ERRATA CORRIGE

Please find here attached the pages that have to be replaced in the basic Service Bulletin n°109EP-173 Rev./.

SERVICE BULLETIN**N° 109EP-173****ALERT****DATE:** November 10, 2020**REV. :** /

TITLE**ATA 53 - CENTRAL FUSELAGE FRAME ASSY AT STA 1815, INSPECTION AND REPAIR
OF****REVISION LOG**

Figure 1

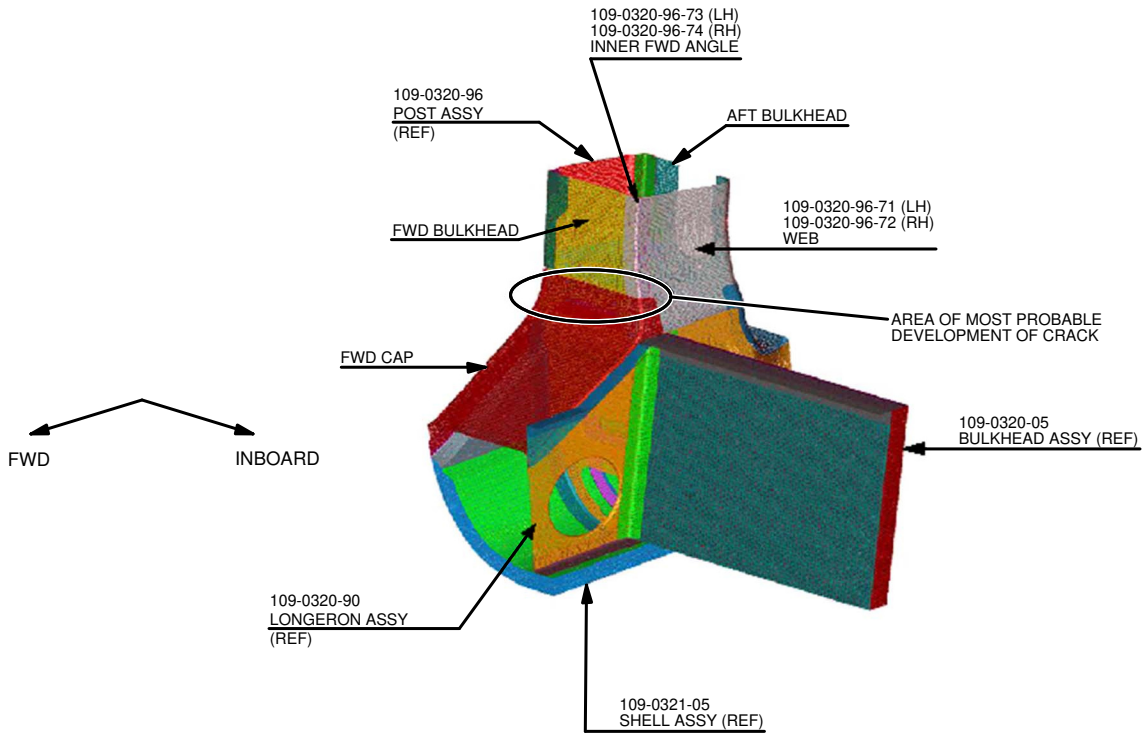
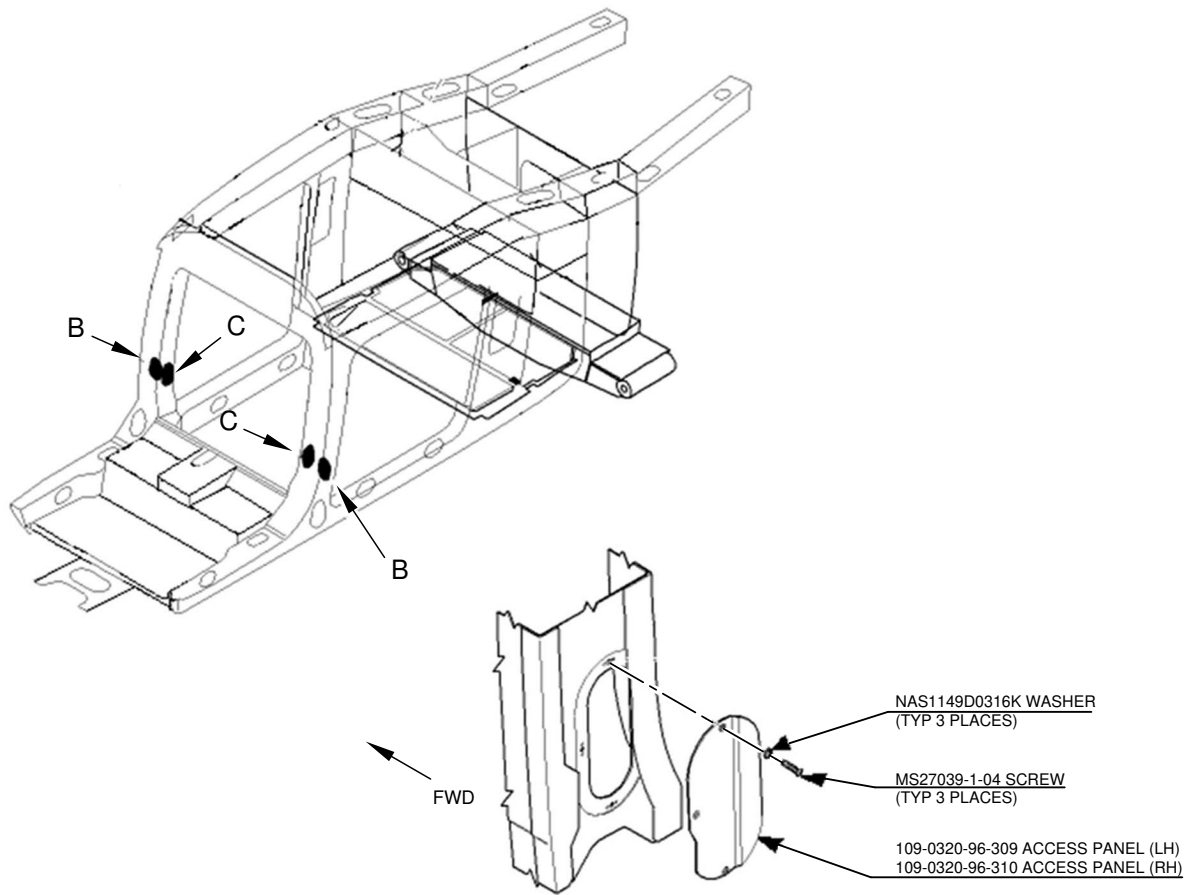
- **PAGE 11 “Step 9.1”**

Was:

If the length of crack(s) does not exceed the boundaries of the FWD CAP, FWD bulkhead or WEB (ref. Figure 1) proceed in accordance with PART II (LH side of fuselage) or PART III (RH fuselage) of this Service Bulletin before the next flight.

- **PAGE 11 “Step 9.2”**

Was:

If the length of the cracks exceeds the boundaries of the FWD CAP, FWD bulkhead or WEB (ref. Figure 1), the repair scheme reported in this Service Bulletin could not be applicable. In this case contact Leonardo Engineering Dept engineering.support.lhd@leonardocompany.com.

- **PAGE 33 “Figure 1”**

Illustration has been changed.

Becomes:

If the length of crack(s) does not exceed the boundaries of the FWD CAP, INNER FORWARD ANGLE or WEB (ref. Figure 1) proceed in accordance with PART II (LH side of fuselage) or PART III (RH fuselage) of this Service Bulletin before the next flight.

Becomes:

If the length of the cracks exceeds the boundaries of the FWD CAP, INNER FORWARD ANGLE or WEB (ref. Figure 1), the repair scheme reported in this Service Bulletin could not be applicable. In this case contact Leonardo Engineering Dept engineering.support.lhd@leonardocompany.com.
